20 February 2019

**Elf Mushroom Farm MP08\_225 MOD 2, 521 The Northern Road Londonderry**

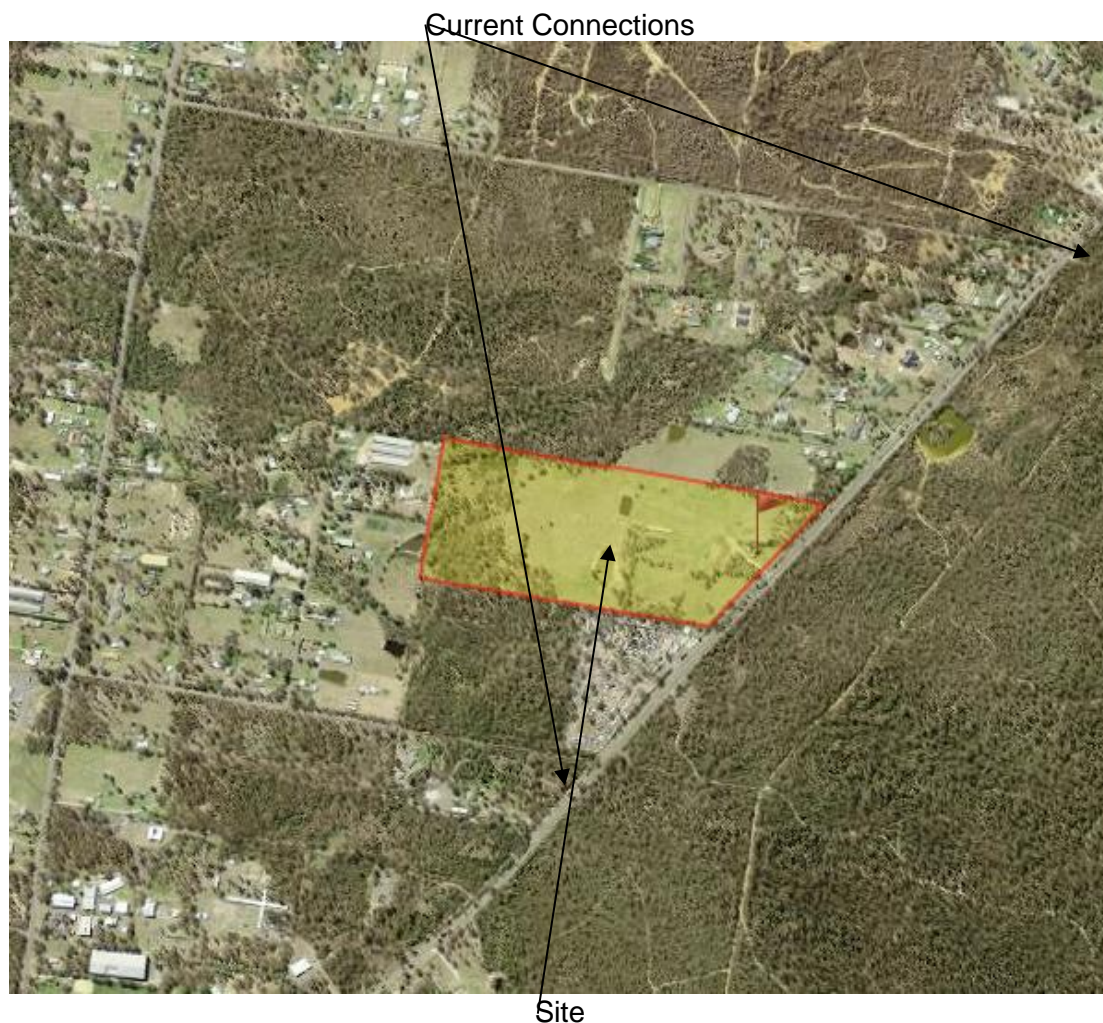
*Site provides opportunity for revegetation and improve connectivity between the nature reserve opposite the site and the vegetation land to the west of the site.*

This matter has been considered and the Flora and Fauna consultant has indicated that to be works successfully a width of at least 10m is required to be provided.

The matter of the 10m wide connectivity and proposed plantings has been discussed with the Bushfire Consultant and the impact on the bushfire threat to the proposed mushroom growing buildings.

The consultant has indicated that any additional landscaping along the southern boundary will impact and increase the potential bushfire risk to the buildings.  
(The response from the Consultant is attached)

The Council seeks this planting to improve the connectivity between the Castlereagh Nature Reserve to the east and the remnant vegetation to the west to allow a safer passage for mobile fauna moving through the area.

The Castlereagh Nature Reserve is current separated from the site by a main arterial road (The Northern Road) which carries a large volume of traffic and does not allow safe passage for some fauna.

The immediate area adjacent to the site provides suitable connections between the Castlereagh Nature Reserve and the remnant vegetation to the west.  
(Refer to aerial photo below showing the existing connections)

Extract from the Acoustic report showing the Assessment locations

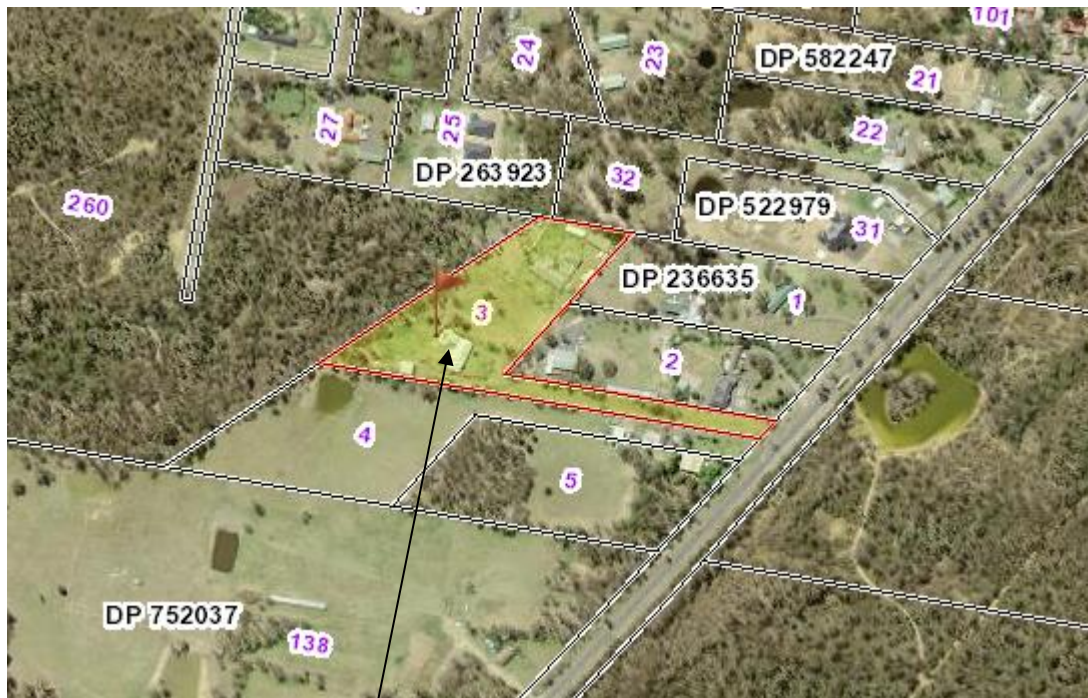
Noise report did not include their property as a receiver and wanted to know why.

The report has looked at the immediate properties as receivers and the results have indicated that except for 1 Thomas Road on the southern side of the building all other receivers the predicated noise levels are within the acceptable levels.

The subject property is further away from the adjoining property and it would assume that the predicated noise level would be further reduced and would still meet the acceptable noise level.

The R1 receiver is 503 The Northern road and not 493 The Northern Road.

The aerial photo below shows the location of 503 and the extract from the noise report showing the assessment locations shows the dwelling at 503 as R1.

The acoustic report has been adjusted to show the correct address for R1.
